ARCHITECTURAL REVIEW BOARD MEETING
CITY HALL, 385 SOUTH GOLIAD STREET, ROCKWALL, TEXAS
JULY 28, 2026 IN THE CITY COUNCIL CONFERENCE ROOM AT 5:00 PM

PROJECT COMMENTS

PROJECT NUMBER: SP2026-014
PROJECT NAME: Site Plan for 5133 S FM 549
SITE ADDRESS/LOCATIONS: 5133 South Farm to Market 549, Rockwall, TX, 75032

PLANNING AND ZONING COMMISSION MEMORANDUM

LANDSCAPE PLAN

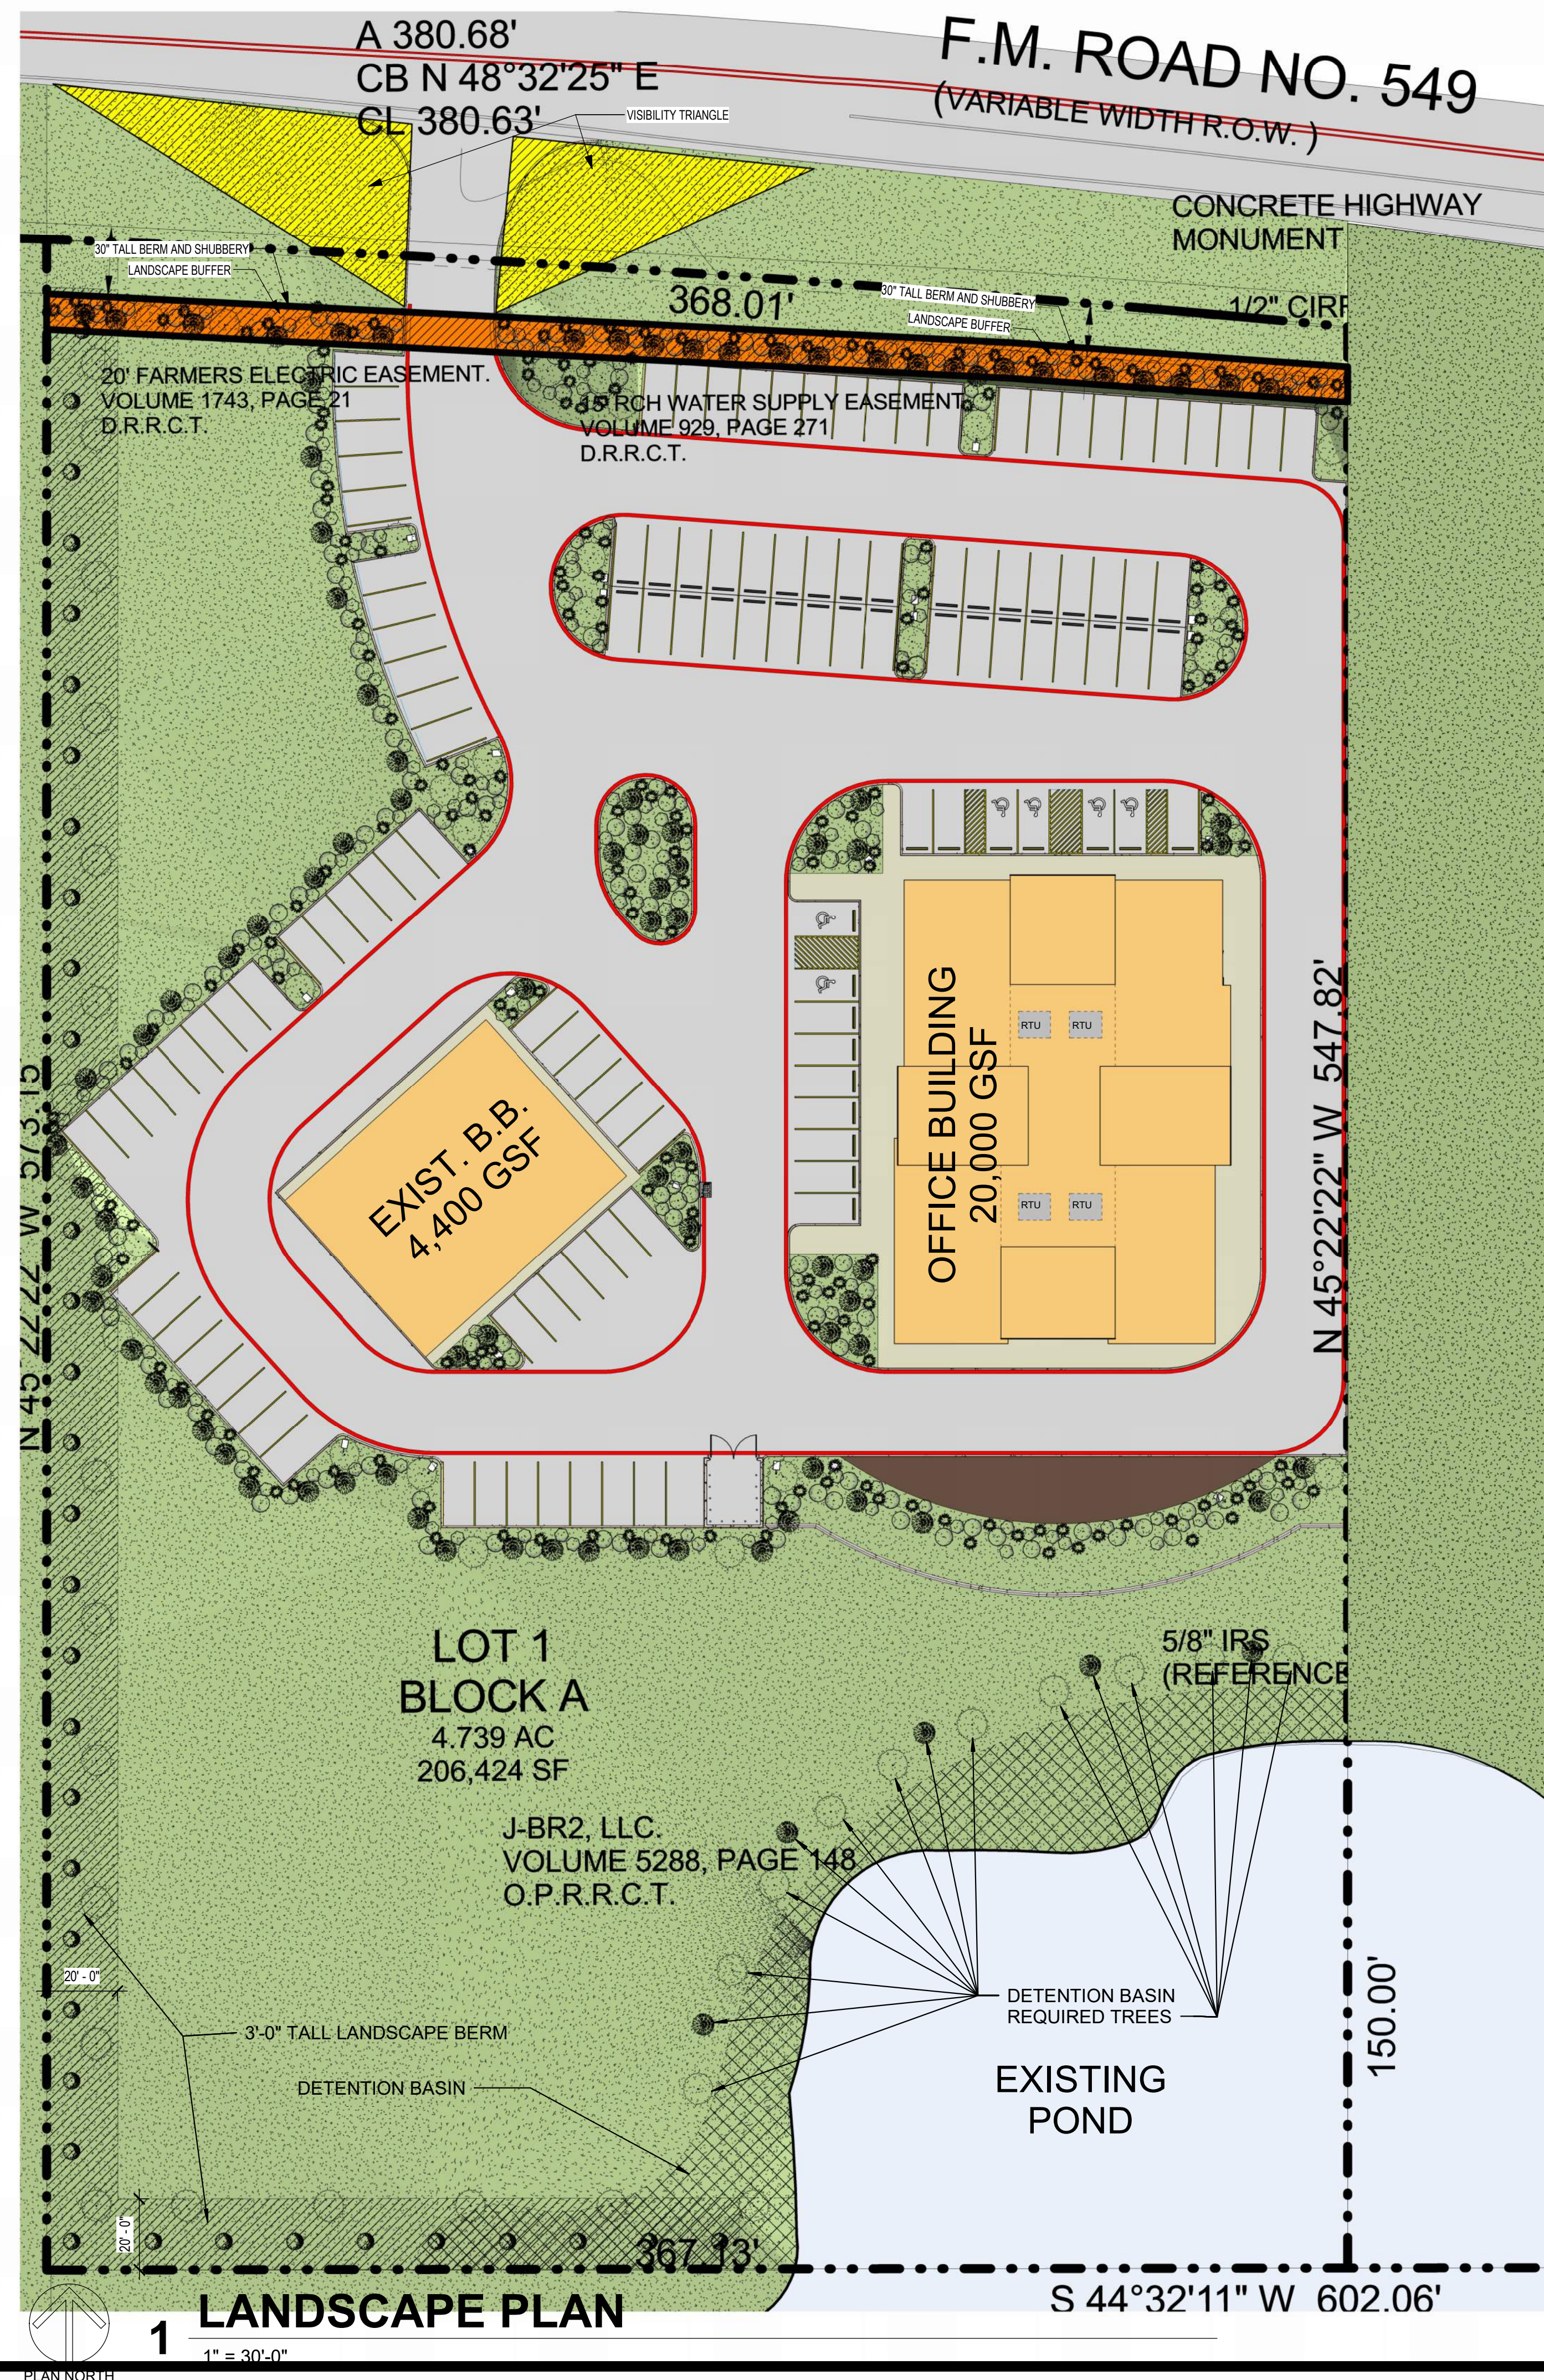
5. All parking spaces must be located within 80 feet of a canopy tree. Please revise the plans to demonstrate compliance with this requirement.

PHOTOMETRIC PLAN

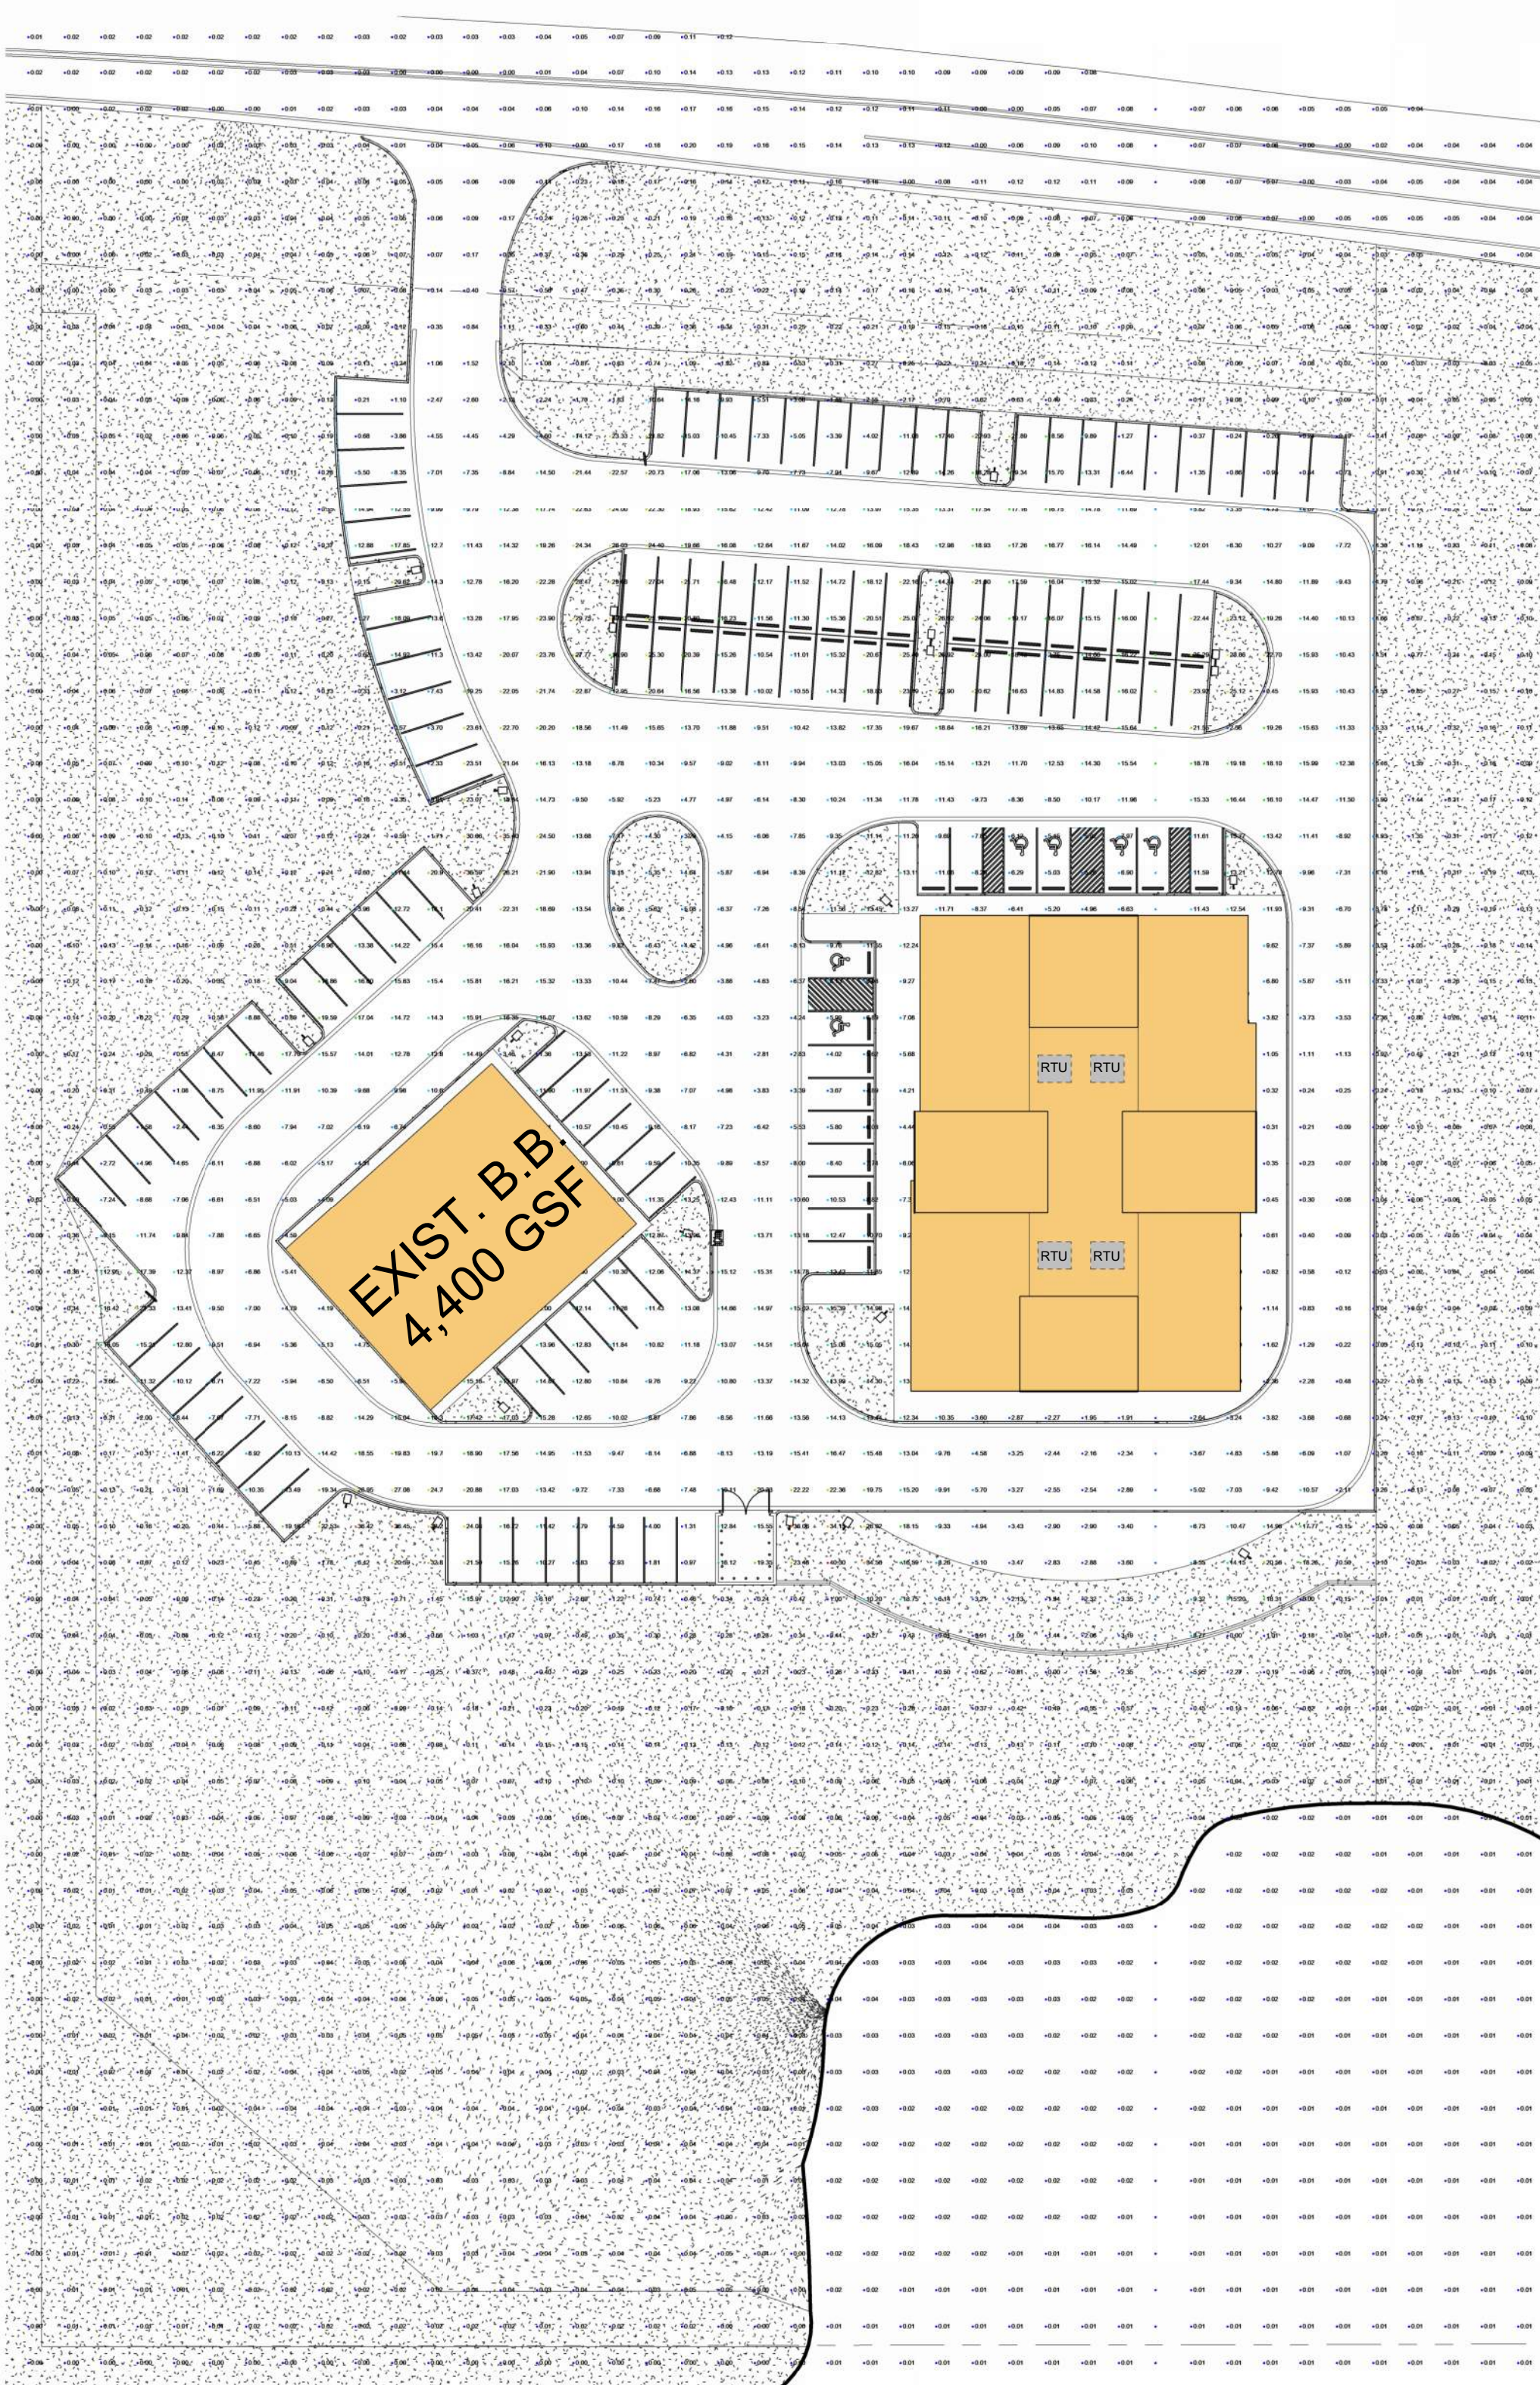
2. The allowable maximum light intensity measured at the property line of a non-residential property is 0.2 FC of one footcandle. The light levels along the northern, eastern, and western property lines exceed the maximum values. Please correct this.

3 EAST ELEVATION

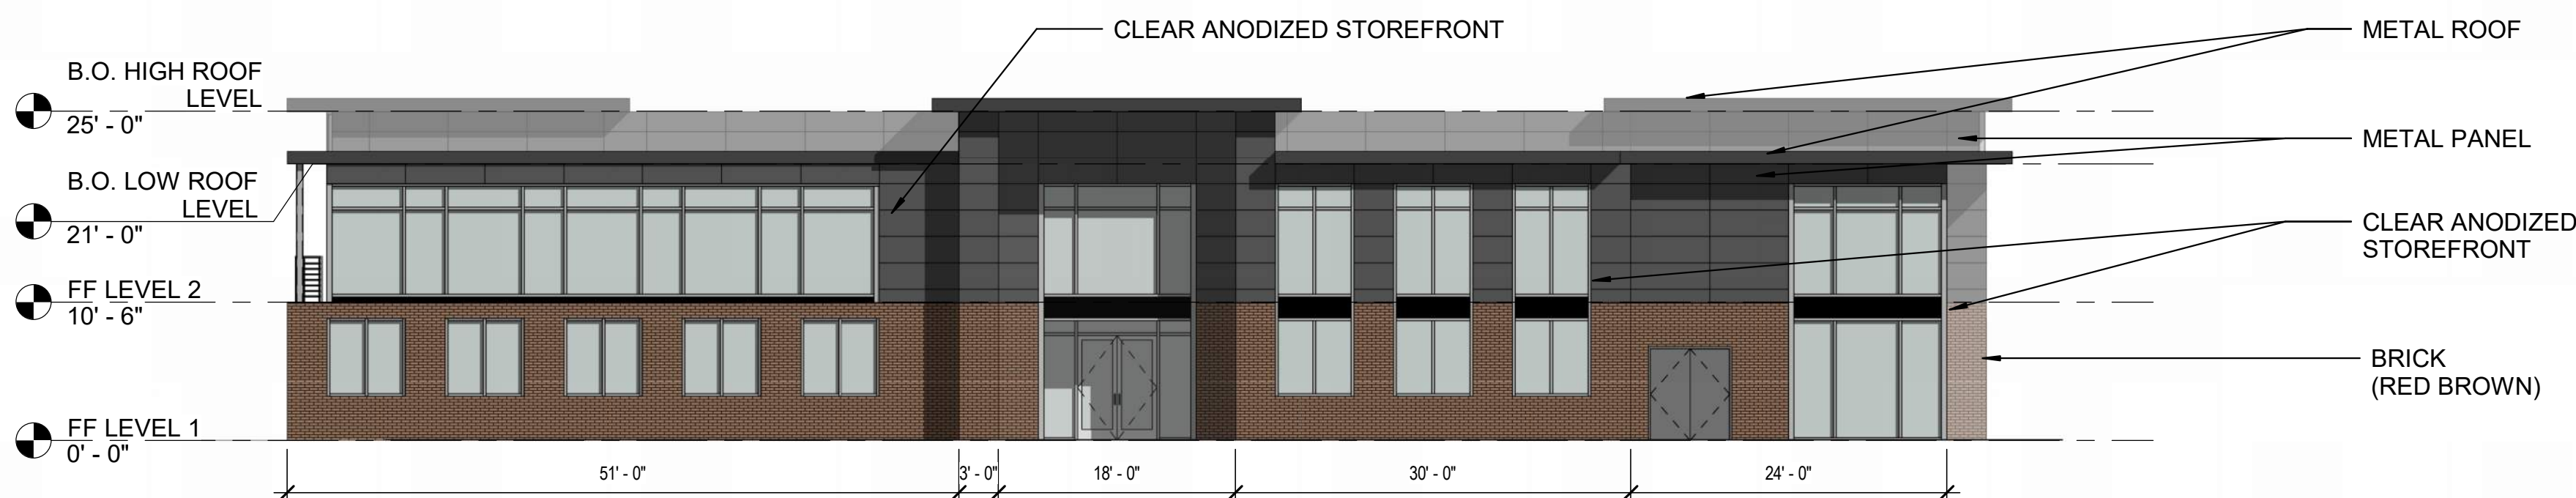
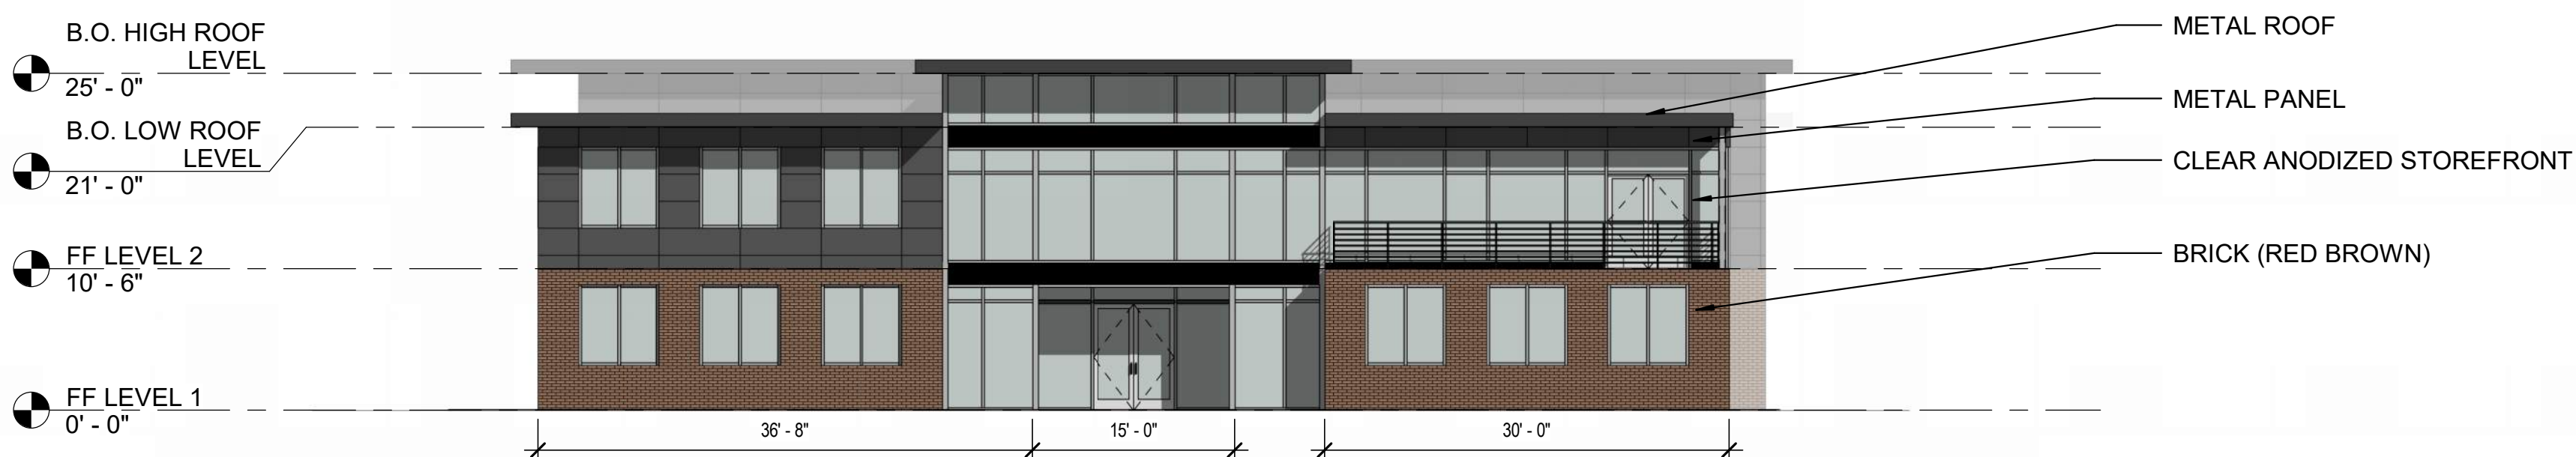
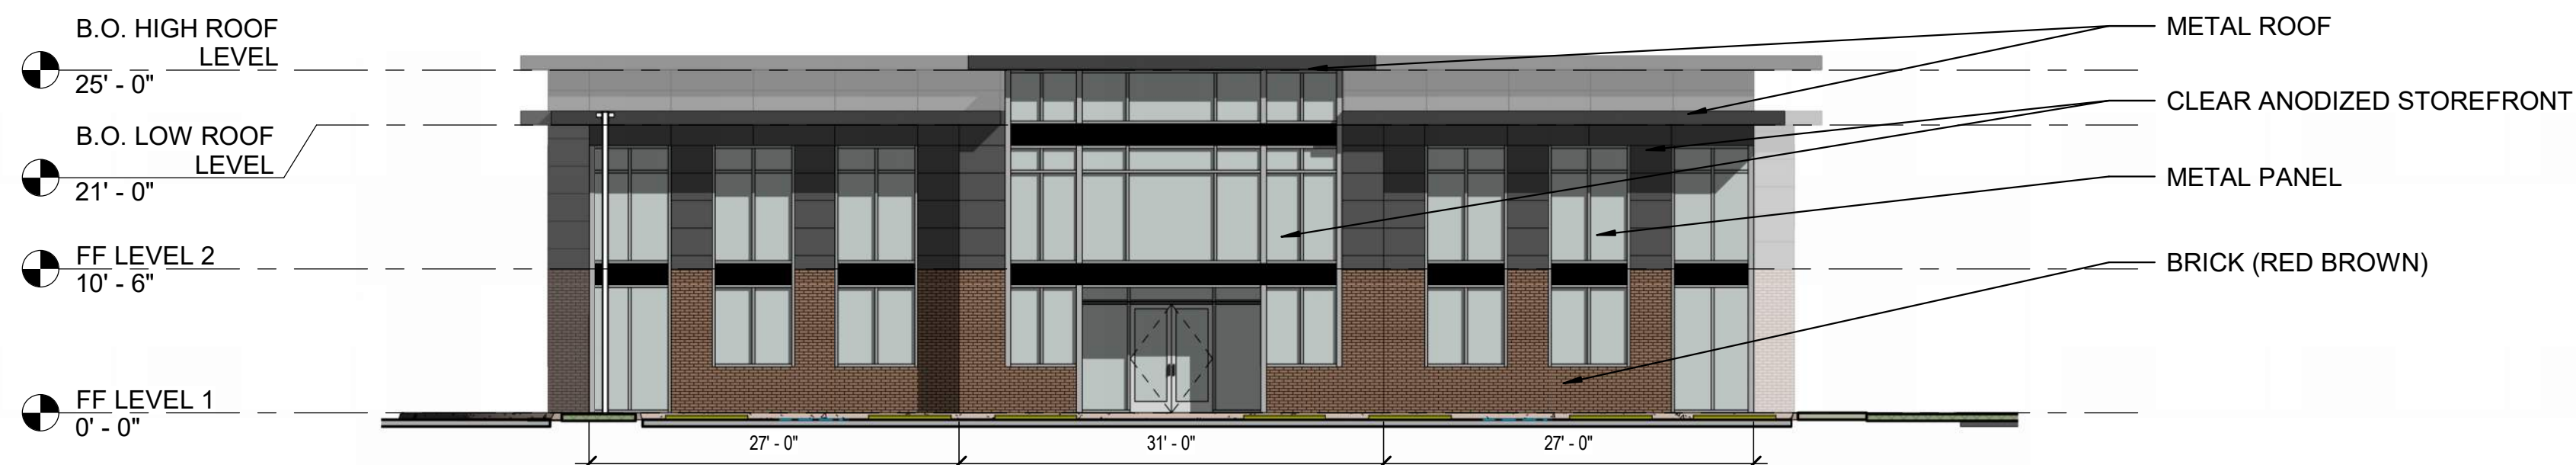
6. Clearly identify the building elevations that face or are adjacent to FM 549.

7. All parapets must extend toward the rear of the building and be finished on the backside with the same materials and level of finish as the front. Please add a note to the plans confirming this requirement.

8. All rooftop mechanical equipment must be fully screened from view. If any rooftop units are visible following construction, the Certificate of Occupancy will not be issued until the screening deficiencies have been corrected.

- o Incorporate parapets into the building design;
- o Show the rooftop units as dashed elements on the elevations;
- o Increase the architectural articulation of the building; and
- o Revise the roof design and building massing to be more compatible with the surrounding residential area.
